TRANS/WP.29/GRE/2002/3/Rev.1
7 July 2003

PROPOSAL FOR DRAFT AMENDMENTS TO REGULATION No. 65

(Special warning lamps)

Transmitted by the Experts from France, Germany and the United Kingdom

Item 2, amend to read:

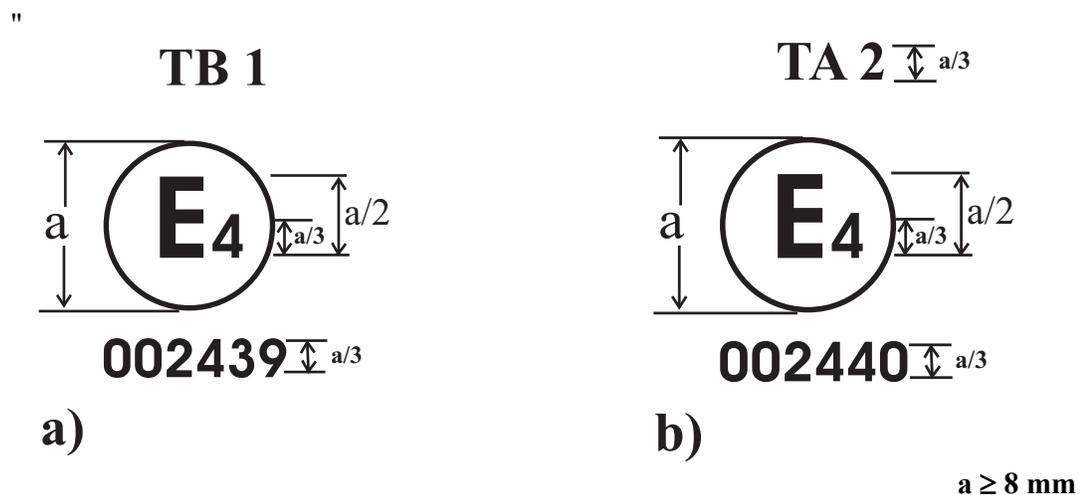
"2. Special warning lamp has one/ two levels of intensity 2/
Special warning lamp consists of separate units.

Examples of approval marks, amend to read:

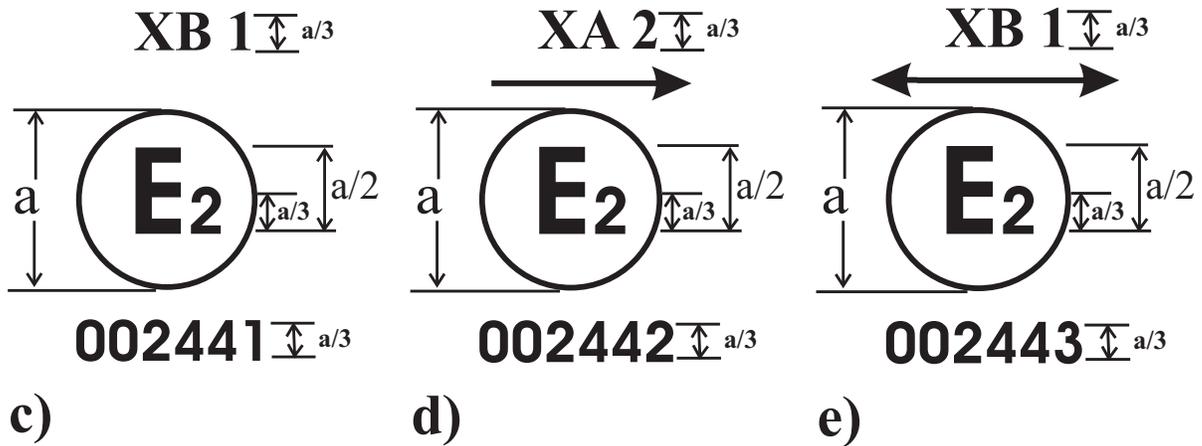
- a) a special warning lamp indicates that it has been approved in the Netherlands (E4) under approval number 002439. The approval number shows that the approval was granted in accordance with the requirements of the Regulation in its original form and that it is a blue rotating or stationary flashing special warning lamp of class 1 (TB 1).
- b) a directional flashing lamp indicates that it has been approved in the Netherlands (E4) under approval number 002440. The approval number shows that the approval was granted in accordance with the requirements of the Regulation in its original form and that it is a amber rotating or stationary flashing special warning lamp of class 2 (TA 2)."

- c) a directional flashing lamp indicates that it has been approved in France (E2) under approval number 002441. The approval number shows that the approval was granted in accordance with the requirements of the Regulation in its original form and that it is a blue directional flashing lamp of class 1 (XB 1).

The marking without an arrow indicates that the lamp has a narrow-angle effect.

- d) a directional flashing lamp indicates that it has been approved in France (E2) under approval number 002442. The approval number shows that the approval was granted in accordance with the requirements of the Regulation in its original form and that it is a amber directional flashing lamp of class 2 (XA 2).

The arrow indicates that the lamp has a wide-angle effect on the side indicated by the direction in which the arrow is pointing, which also indicates the side of the vehicle on which the device is to be mounted.

- e) a directional flashing lamp indicates that it has been approved in France (E2) under approval number 002443. The approval number shows that the approval was granted in accordance with the requirements of the Regulation in its original form and that it is a blue directional flashing lamp of class 1 (XB 1).

The double side arrow indicates that the lamp has a wide-angle effect to both sides, which also indicates that the lamp could be mounted on both side of the vehicle.

- 7.3.1. Table of standard light distribution for special warning flash lamp (Category X)

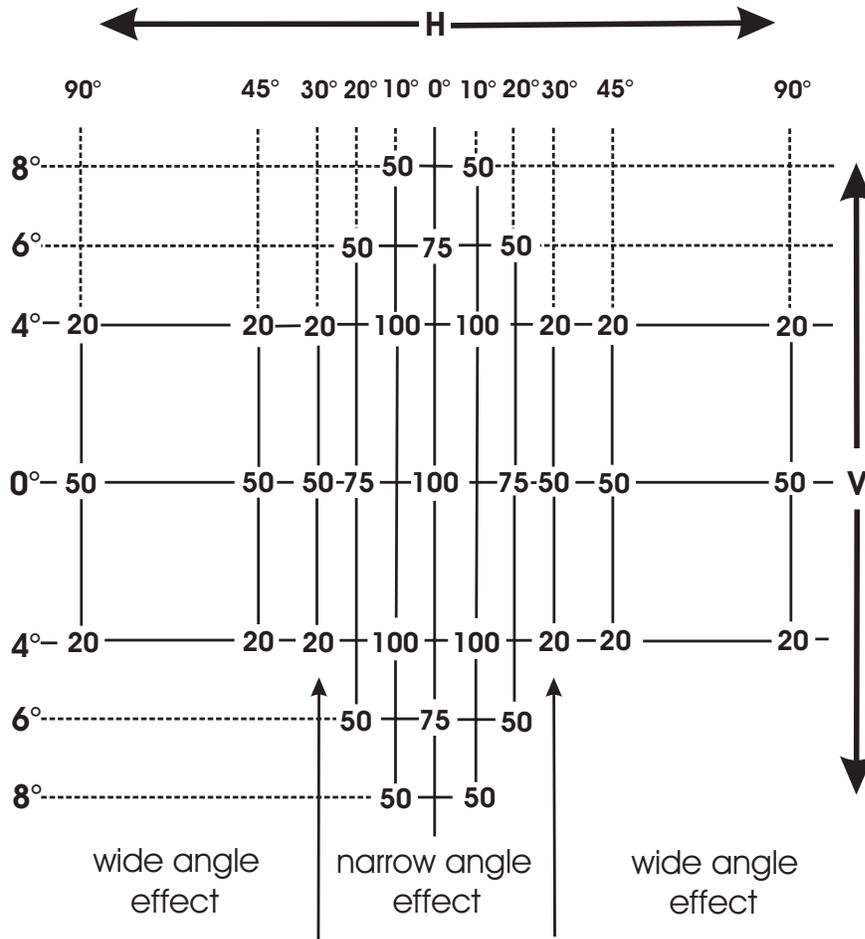
- 7.3. The effective luminous intensities in the reference axis for a directional flashing lamp (Category X) shall be as specified in the table below:

Category X			Colour	
			blue	amber
Minimum value of the effective luminous intensity I_e on the reference axis	$H = 0^\circ$ $V = 0^\circ$	by day	200	400
		by night	100	200
Maximum value of the effective luminous intensity J_e	inside $H = \pm 10^\circ$ $V = \pm 4^\circ$	by day	3000	1500
		by night	1500	600
	inside $H = \pm 20^\circ$ $V = \pm 8^\circ$	by day	1500	1500
		by night	600	600
	Outside the above areas	by day	1000	1000
		by night	300	300

Minimum horizontal angular range of category "narrow angle effect" is 30° left to 30° right and for category "wide angle effect" 90° directed outwards the vehicle and 30° to the inside.

- 7.3.1.1. The direction $H = 0^\circ$ and $V = 0^\circ$ corresponds to the reference axis. (On the vehicle it is horizontal, parallel to the median longitudinal plane of the vehicle and oriented in the required direction of visibility). It passes through the centre of reference. The values shown in the table give, for the various directions of measurements, the minimum intensities as a percentage of the minimum required in the axis for each lamp (in the direction $H = 0^\circ$ and $V = 0^\circ$).
- 7.3.1.2. Within the field of light distribution of paragraph 7.3.1. schematically shown as a grid, the light pattern should be substantially uniform, i.e. the light intensity in each direction of lowest minimum value being shown on the grid lines surrounding the questioned direction as a percentage."
